DEVELOPMENT ASSESSMENT REPORT	
Application No.	D/2019/360
Address	1 Athol Street, LEICHHARDT NSW 2040
Proposal	Sub-division of existing land into 2 lots. External renovations to the existing dwelling and use of the ground floor as an office. New alterations and additions to the existing warehouse and conversion to a dwelling. Changes to parking arrangements.
Date of Lodgement	13 September 2019
Applicant	Sandbox Studio Pty Ltd
Owner	Robert Hardie and Diane Hardie
Number of Submissions	Nil
Value of works	\$734,000
Reason for determination at Planning Panel	Clause 4.6 variation exceeds 10%
Main Issues	Floor Space Ratio
Recommendation	Approved with Conditions
Attachment A	Recommended conditions of consent
Attachment B	Plans of proposed development
Attachment C	Clause 4.6 Exception to Development Standards

1. Executive Summary

This report is an assessment of the application submitted to Council for subdivision of existing land into 2 lots, external renovations to the existing dwelling and use of the ground

DRIVEWAY PLAN
1:30

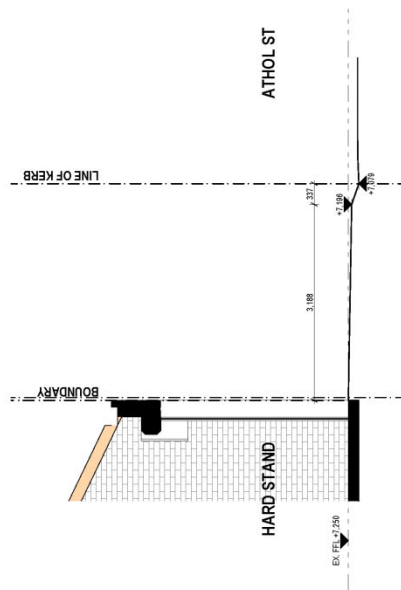
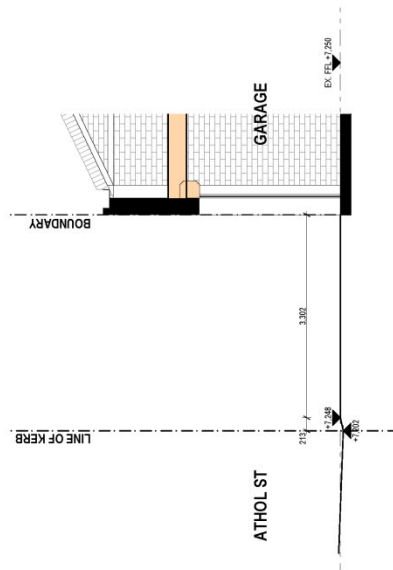
The proposal seeks to provide a new garage door opening and crossover for the new dwelling on Lot 2. To ensure vehicles can enter and exit the parking space, a condition will be recommended to increase the width of the garage door to 3000mm, which will match the existing garage door opening for the office premises on Lot 1. The increase of door/driveway does not result in the loss of any legal existing on-street parking.
